Re: Site-Specific Risk-Based Cleanup Level Calculations, Draft Annotated Outline for Risk-Based PCB Cleanup Plan, and Responses to Comments, Former Westinghouse Apparatus Repair Plant, Rancho Dominguez, California

Former Westinghouse Apparatus Repair
Facility – Rancho Dominguez, California

Enclosure C - Response to EPA's Comments from May 18, 2016

CBS Post Cleaning Sampling – Former Westinghouse Facility, Rancho Dominguez, CA

FIGURE 3

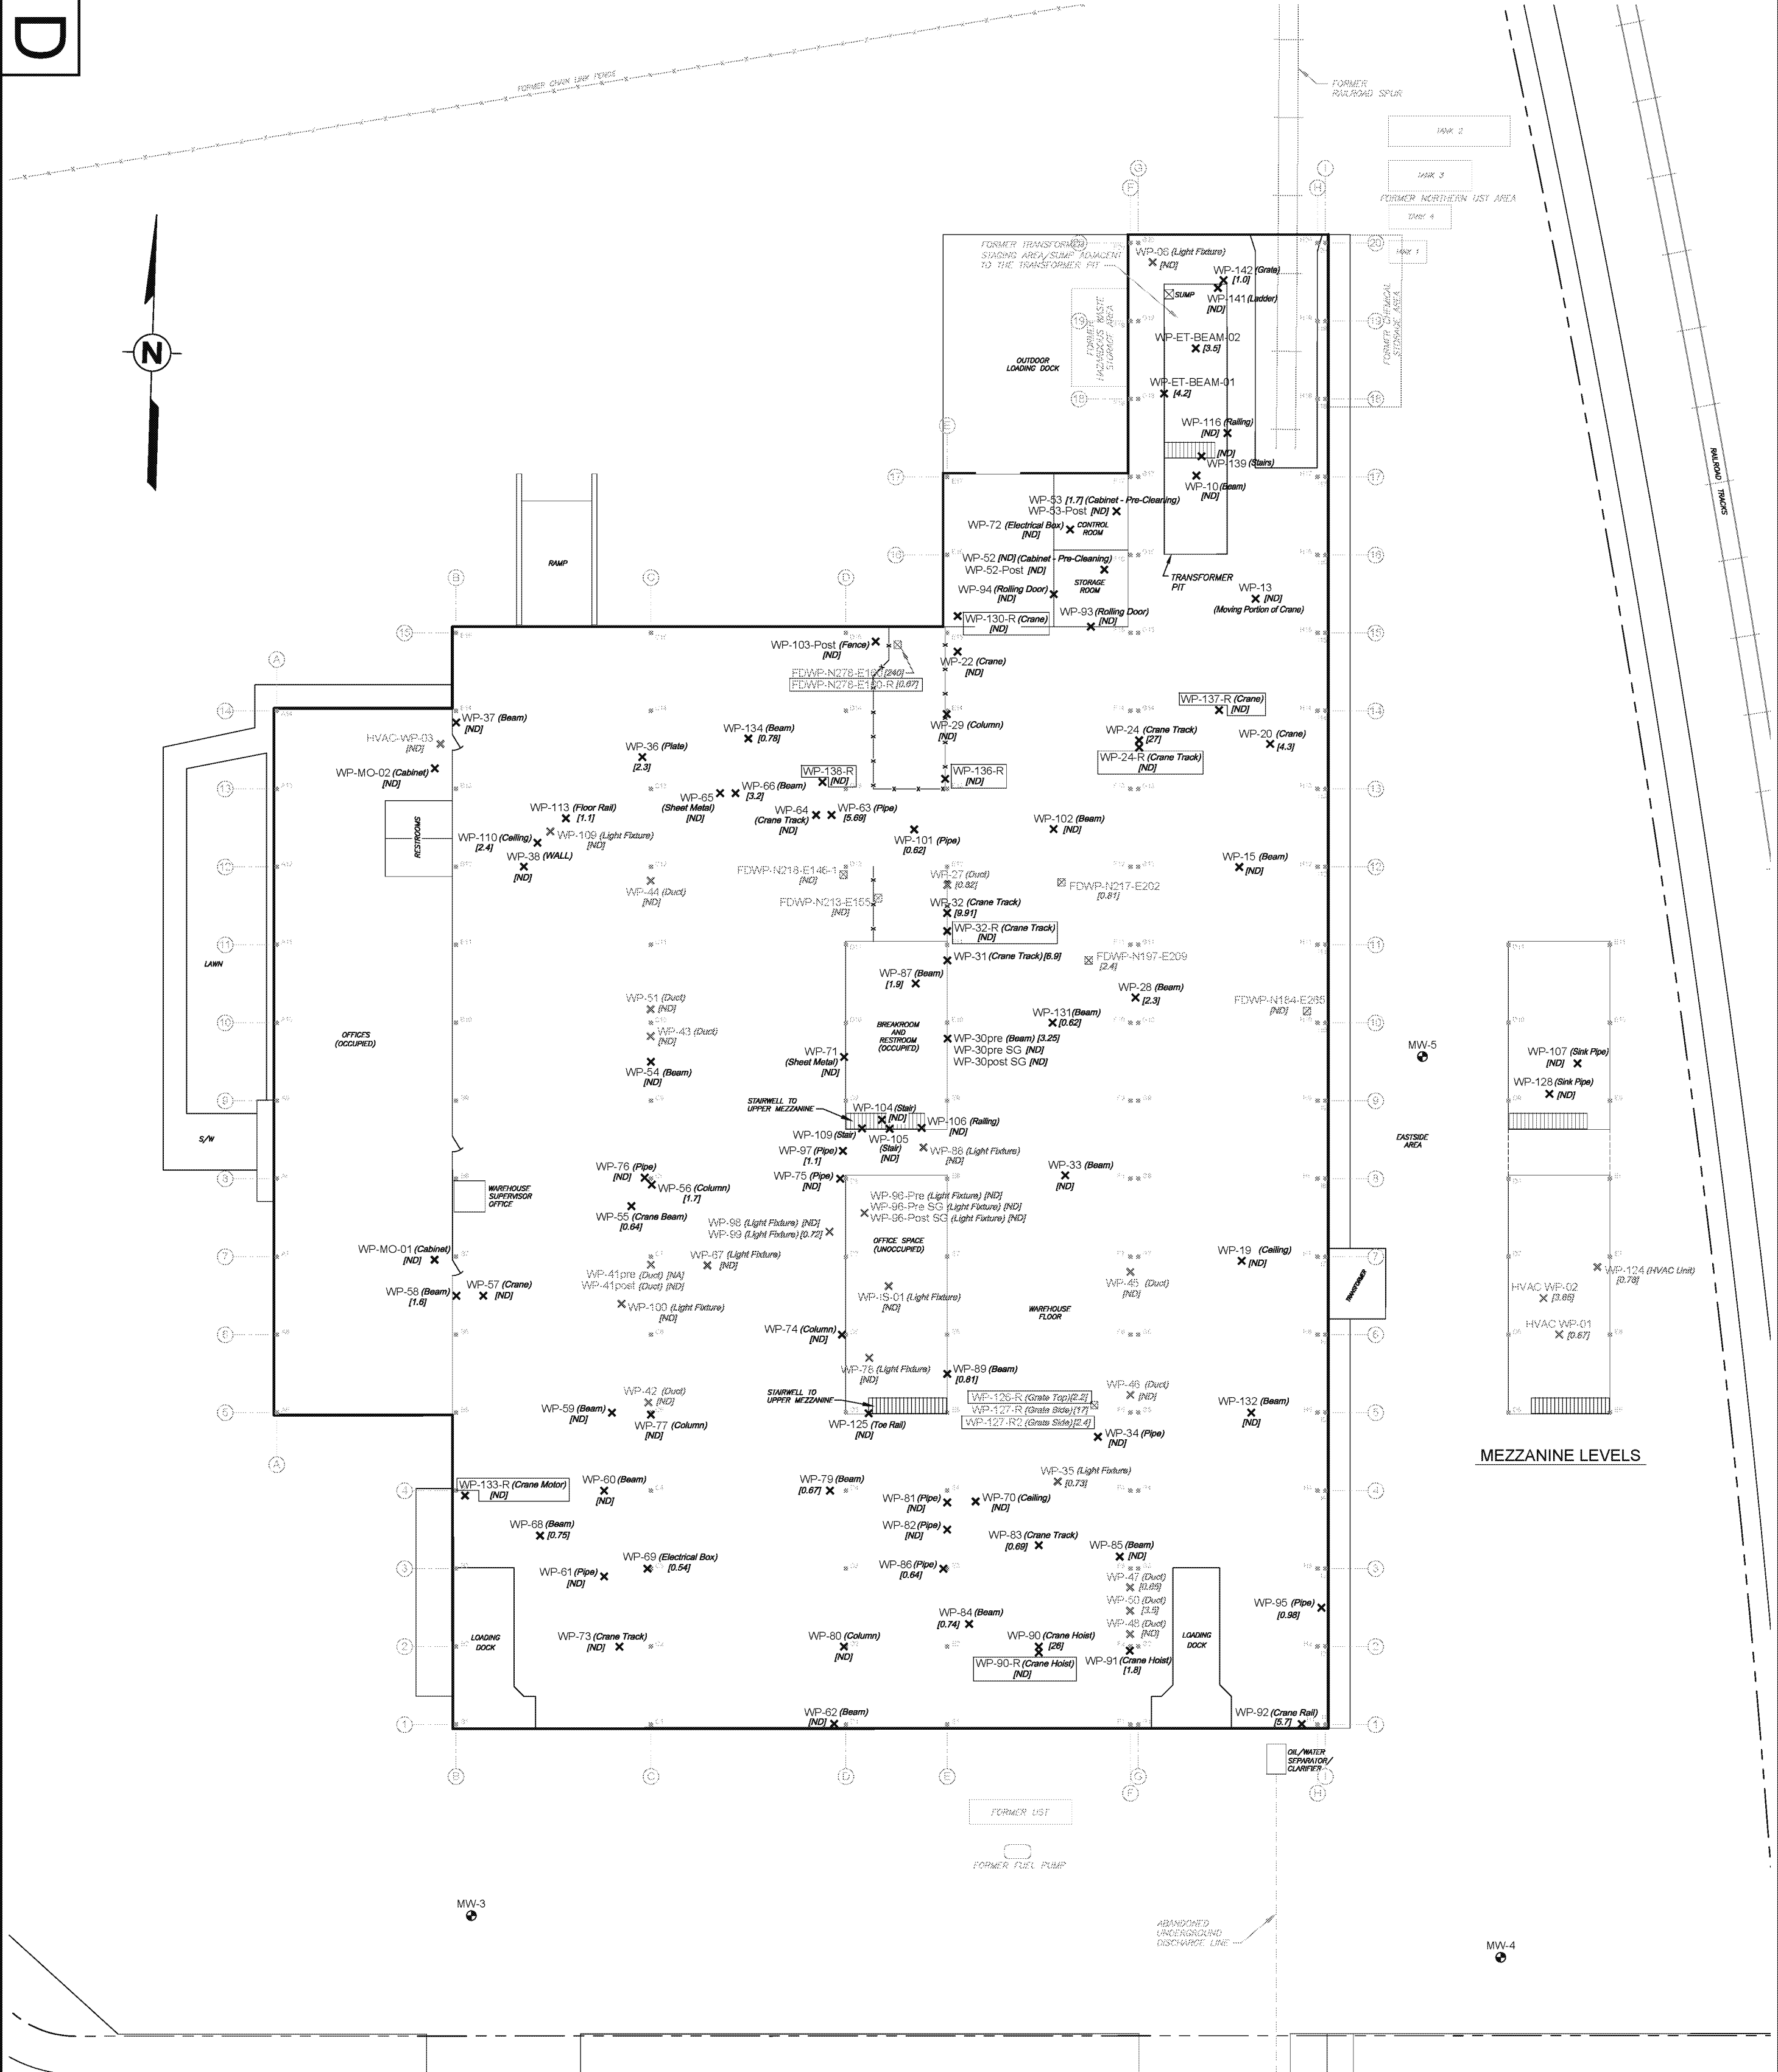
- a. We would like to further evaluate this data and need additional figures. Please provide a figure that properly identifies each of the wipe samples collected (1) after cleaning and (2) after re-cleaning.

The samples of the re-cleaned surfaces are identified by the letter “R” at the end of the sample identification shown on both the figures and tables. On the revised wipe sample figure (enclosed), sampled identifications are boxed to denote a “re-cleaned” sample.

Notably, most of the surfaces that were re-cleaned are associated with the crane and crane rails that were found to contain oil and grease that were not easily removed using the Simple Green™ solution. The greasy equipment was re-cleaned using undiluted solution and more aggressive scrubbing techniques.
